ADDENDUM NO. 4

TO: PLANS AND SPECIFICATIONS FOR STATE OF MISSOURI

**Design & Construct New Premium Sites, Campground Network
Weston Bend State Park
Weston, Missouri
PROJECT NO.: X2221-01**

1. **Sheet E-801:** Updated Note 1B: Changing the 3" to 2" and added Schedule 40.

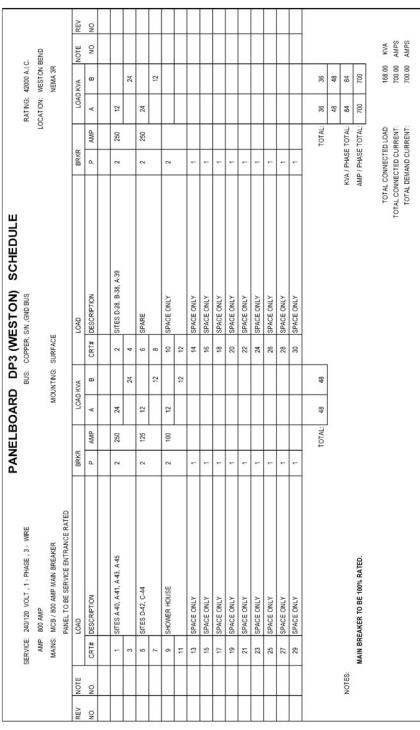
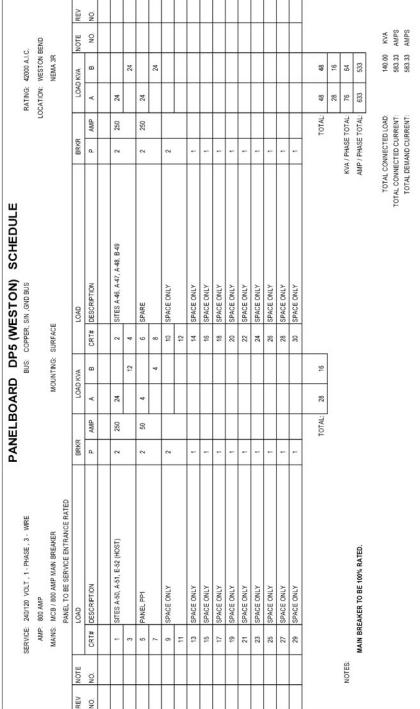
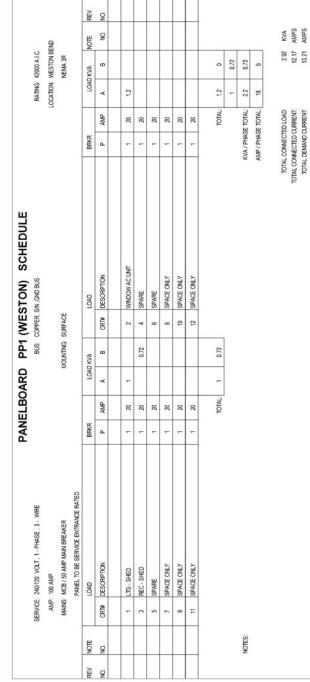
Updated Note 12: Clarified that contractor to install meter can as supplied by Evergy. Evergy to supply meter and install.
